Amendment to the CATPA1401 Payen catalogue

Rectification page 258 – panel 25 concerning the applications of the 8HY (DV4TED4)

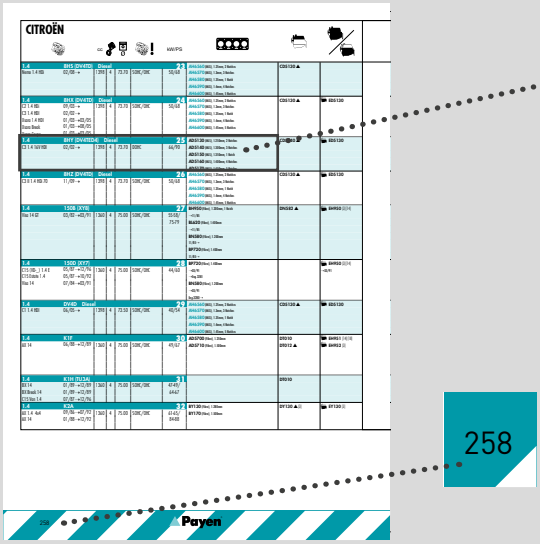
The **AD5130, AD5140, AD5150, AD5160** and **AD5170** cylinder head gaskets can **NOT** be fitted to engine **8HY (DV4TED4).**

1.4	8HY (DV4TED4)	Diesel
~~**AD5130** (MLS), 1.250mm, 2 Notches~~		
~~**AD5140** (MLS), 1.300mm, 3 Notches~~		
~~**AD5150** (MLS), 1.350mm, 1 Notch~~		
~~**AD5160** (MLS), 1.400mm, 4 Notches~~		
~~**AD5170** (MLS), 1.450mm, 5 Notches~~
